SHEET TITLE
SITE PLANS
PROJECT ADDRESS
98 CUTLER ROAD,
CLONTARF

CLIENT
BOWES HOUSE
DOCUMENTATION
-

Drawn	Scale	Sheet	Date	Job N°.	Sheet N°	Issue/Revision
Author	1 : 200	A 3	14.8.19	0155-19	01-S4.55

2 PROPOSED SITE PLAN
1 : 200

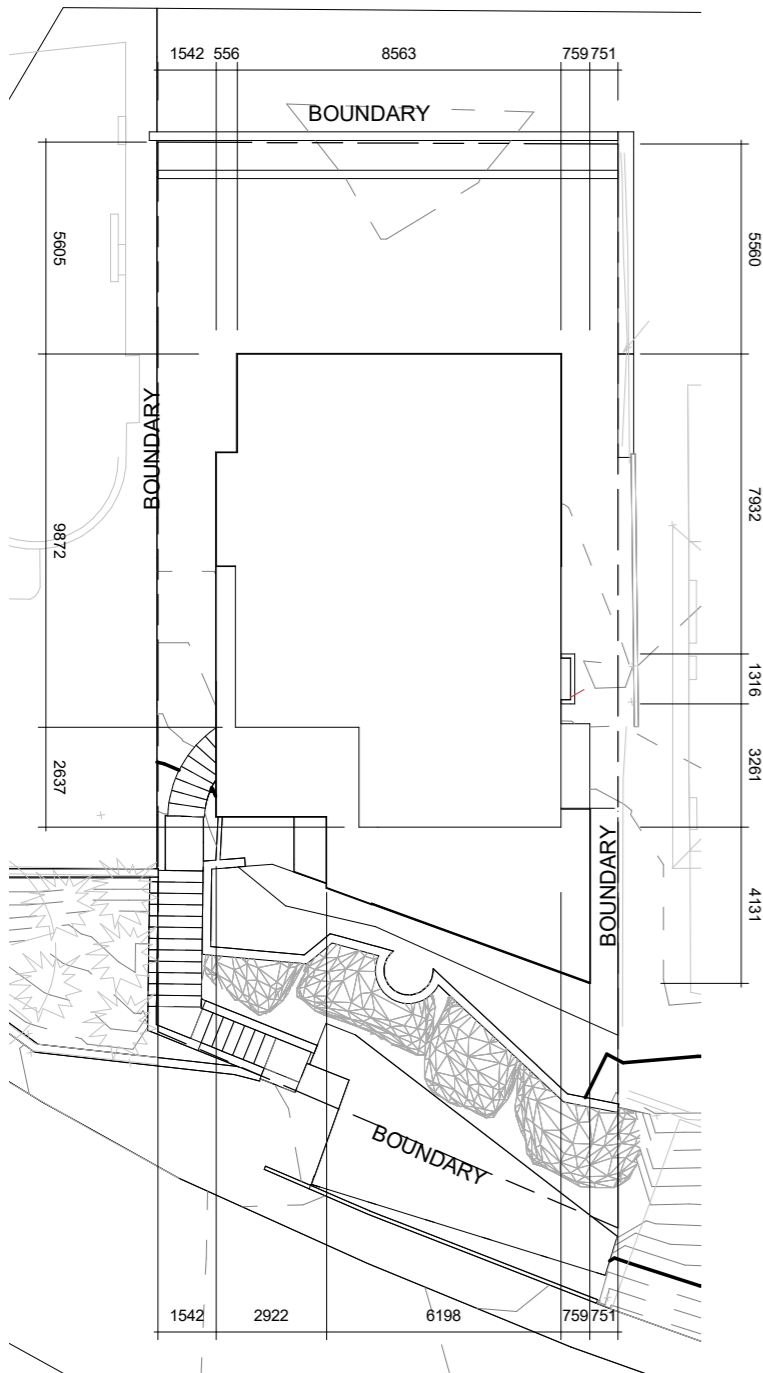
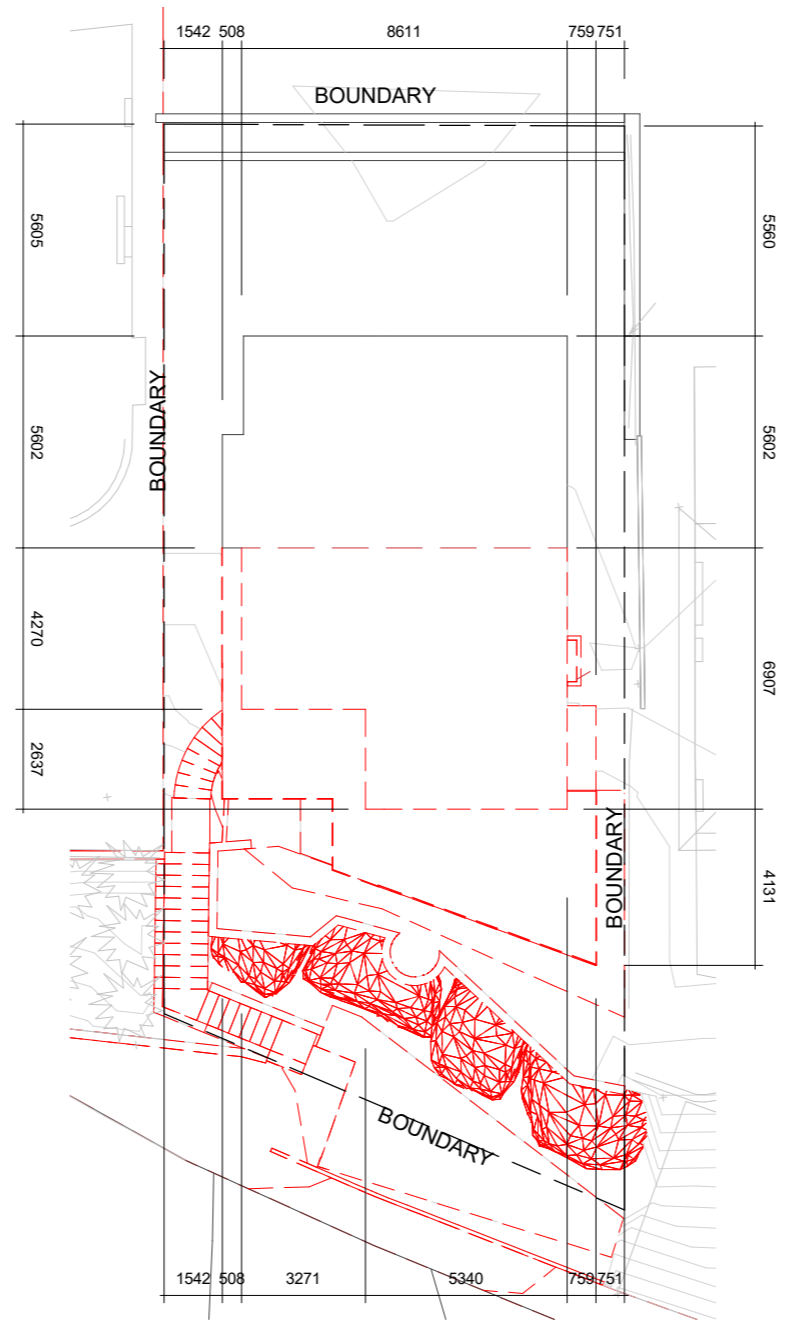
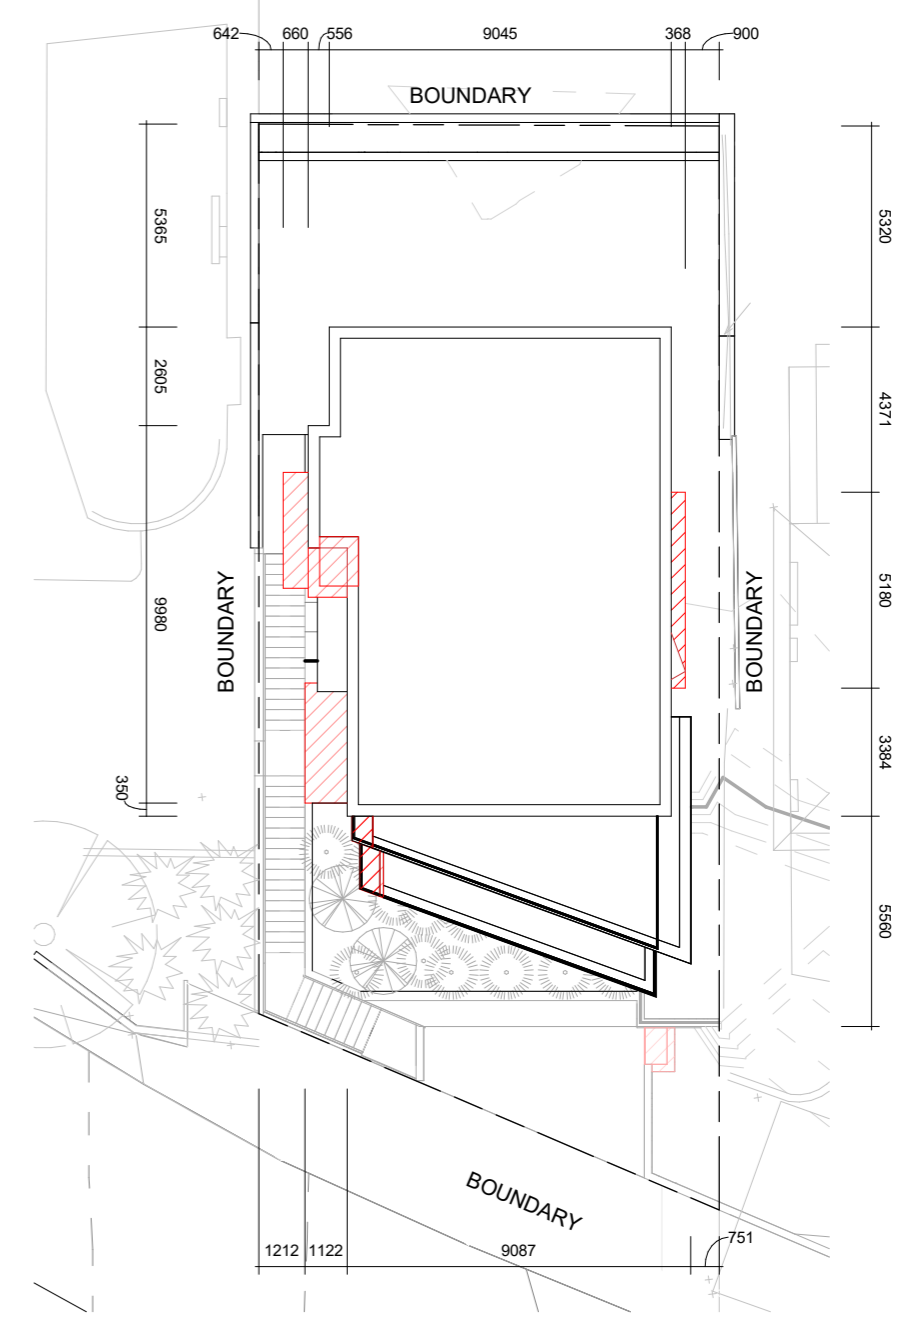
PROPOSED DEMOLITION SHOWN IN RED

MODIFICATIONS OUTSIDE OF THE FOOTPRINT OF THE APPROVED "DA 2018 / 0764" SHOWN IN RED HATCH

03 - Level 3
1 : 100

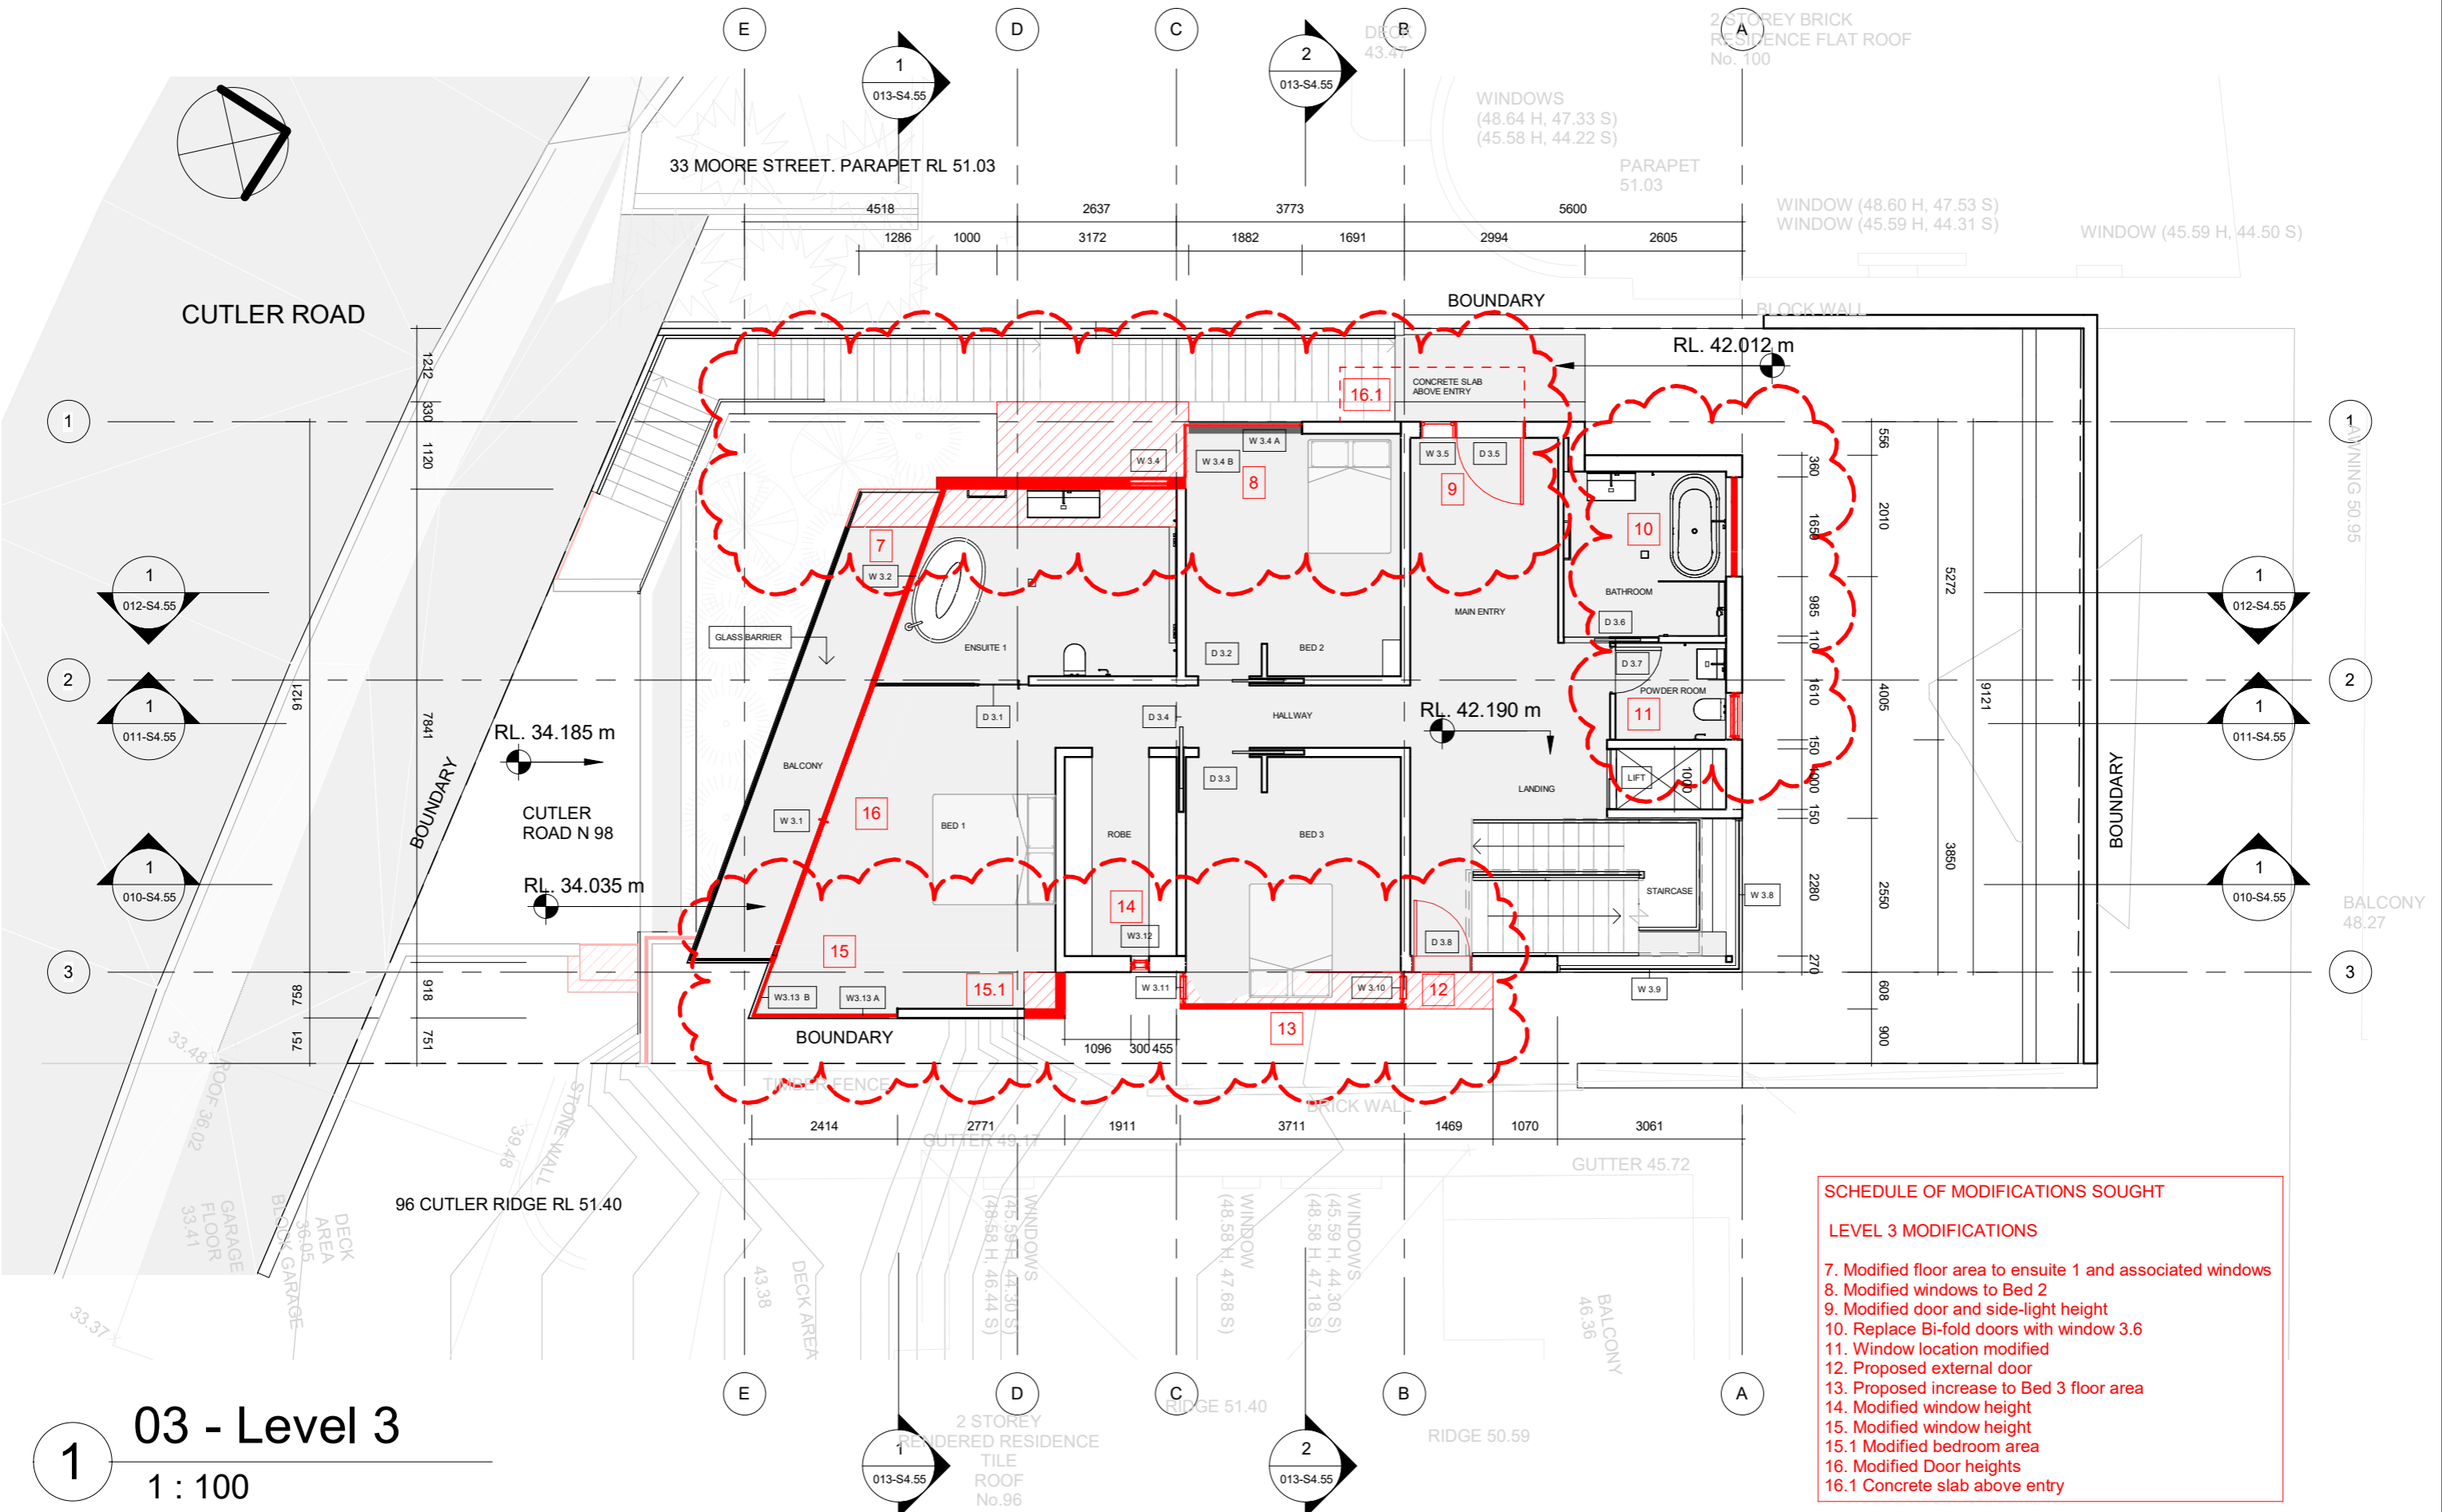
- SCHEDULE OF MODIFICATIONS SOUGHT**
- LEVEL 3 MODIFICATIONS**
- 7. Modified floor area to ensuite 1 and associated windows
 - 8. Modified windows to Bed 2
 - 9. Modified door and side-light height
 - 10. Replace Bi-fold doors with window 3.6
 - 11. Window location modified
 - 12. Proposed external door
 - 13. Proposed increase to Bed 3 floor area
 - 14. Modified window height
 - 15. Modified window height
 - 15.1 Modified bedroom area
 - 16. Modified Door heights
 - 16.1 Concrete slab above entry

02 - Level 2
 1 : 100

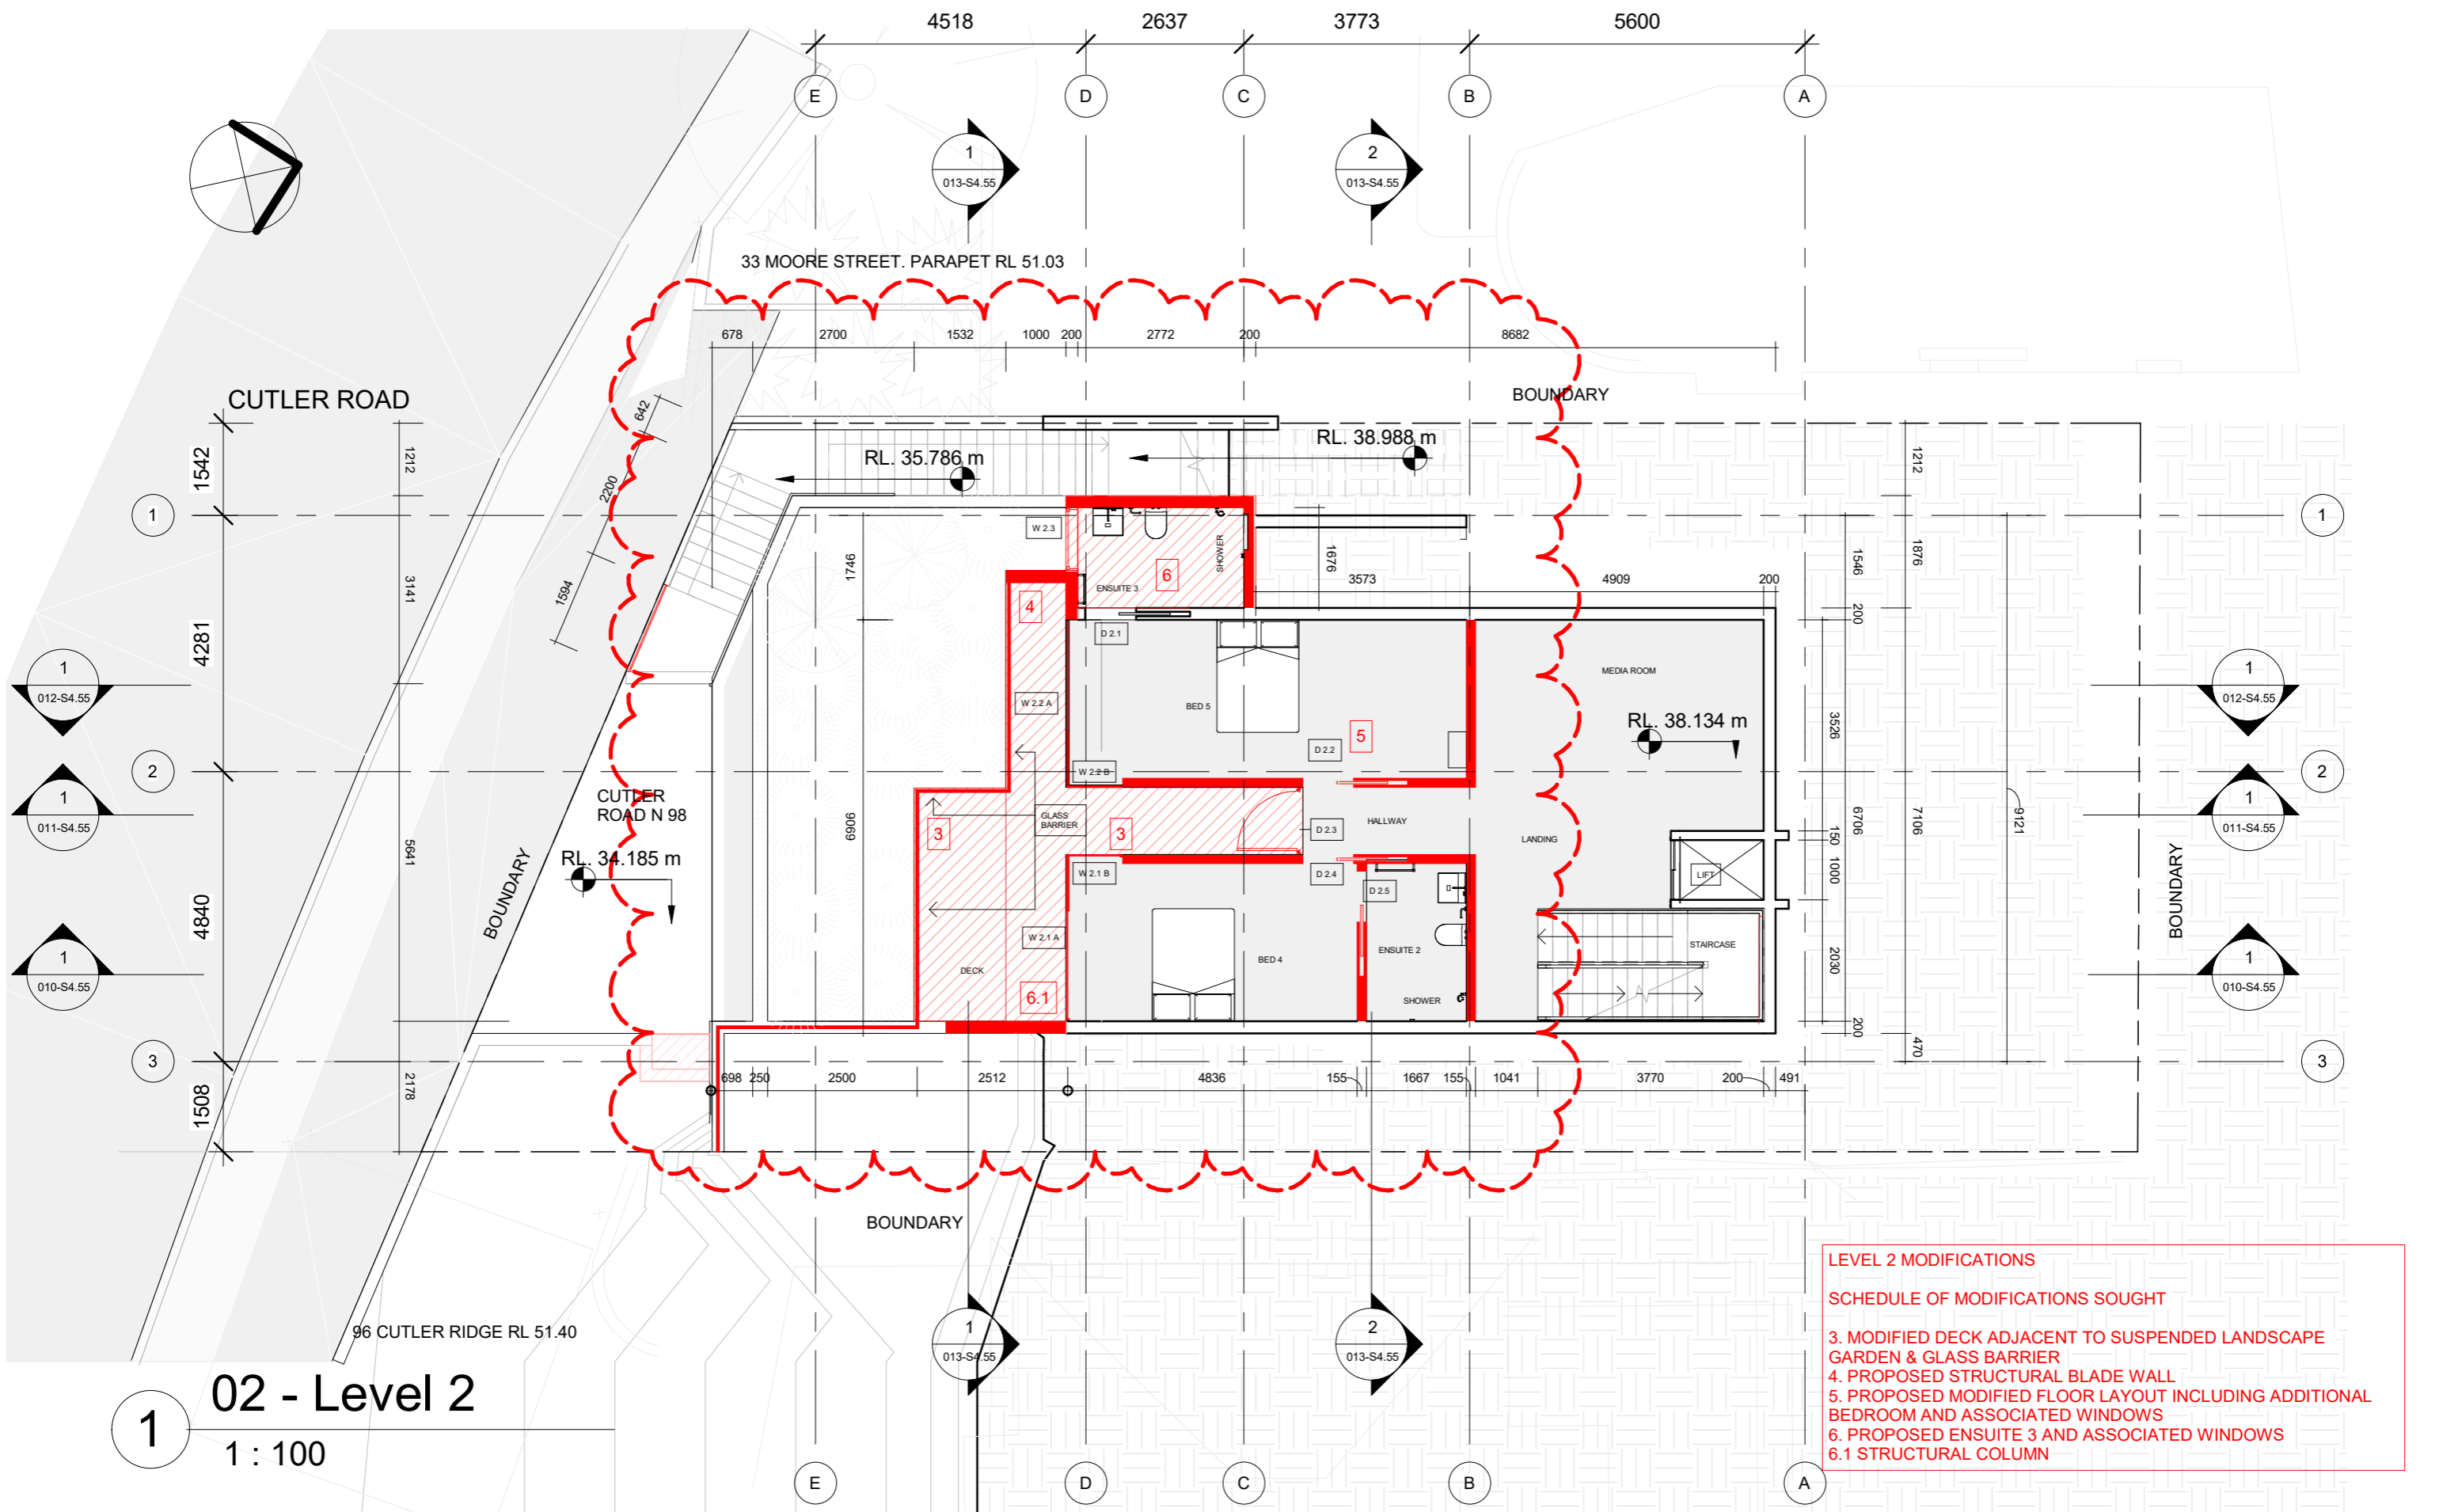
- 3. MODIFIED DECK ADJACENT TO SUSPENDED LANDSCAPE GARDEN & GLASS BARRIER
- 4. PROPOSED STRUCTURAL BLADE WALL
- 5. PROPOSED MODIFIED FLOOR LAYOUT INCLUDING ADDITIONAL BEDROOM AND ASSOCIATED WINDOWS
- 6. PROPOSED ENSUITE 3 AND ASSOCIATED WINDOWS
- 6.1 STRUCTURAL COLUMN
